Department of Planning, Housing and Infrastructure

Re: Objection to SSD-82599709 – Proposed 51 storey mixed use building containing ancillary retail premises, hotel and 296 residential apartments at 153–157 Walker Street, North Sydney

Figure 2: Extract: Surrounding (top) and emerging (below) high-rise context.

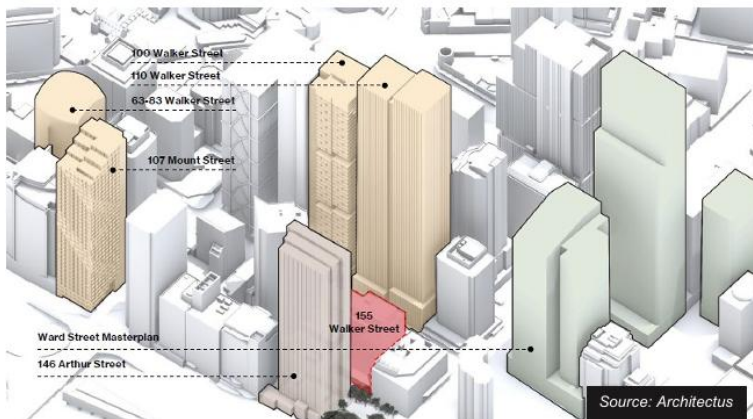
While the applicant claims the variation is justified, at 51 storeys, the scale of the proposed tower is disproportionate to its context and will dominate adjacent buildings and the North Sydney skyline, as illustrated in the plan extract below.

Combined with the approval of a commercial tower at 110 Walker Street and a build to rent tower at 146 Arthur Street, the proposal will result in an overdevelopment of the locality.

Figure 3: Extract: Proposed Tower Heights

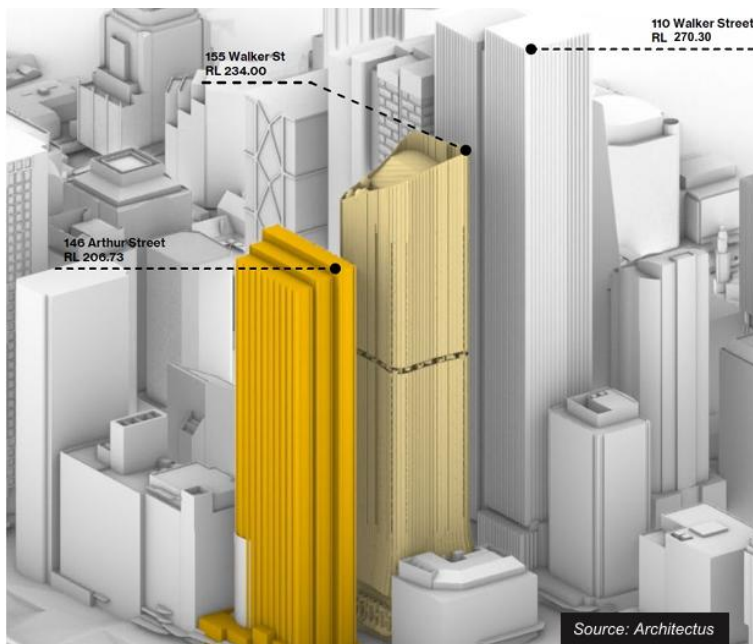
The site is mapped with a maximum building height of RL 215m and the development proposes a non-compliant maximum height of RL 234m (+19m or 8.8%).

- Limit the building height to RL 215m in accordance with NSLEP 2013,
- Require compliance with minimum solar access standards,
- Require a more rigorous assessment of overshadowing impacts on surrounding properties and public open spaces,

Figure 4: Extract from EIS: Access to low rise (left) and high rise (right) views at the site.

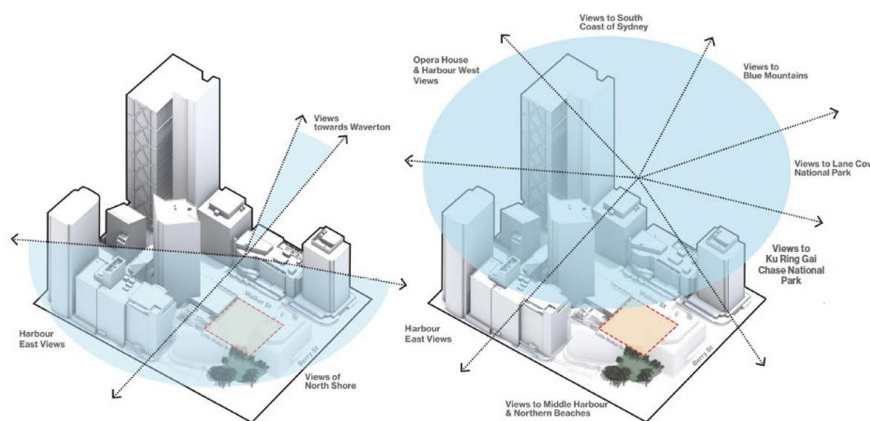
The EIS submitted with this application relies on the Visual Impact Assessment provided with the previously proposed commercial tower (DA393/22 – discontinued) and claims that *there are no formally documented or protected views across the site that would be affected by the proposed development*, despite an acknowledgement of the significant views obtained from the site as illustrated below.

The assumptions in relation to view loss are disputed, as the application does not adequately assess the potential impacts of the development. We anticipate that views will be, to a large degree, lost as a result of the development proposal. Considering the non-compliant building height, reduced setbacks and bulk and scale of the tower, a rigorous assessment is required and a revised development should be considered.

- Require a more rigorous assessment of potential view loss impacts to the iconic views across Sydney Harbour,
- Reduce the scale of the proposed development floor plate to minimise the impacts of overshadowing,
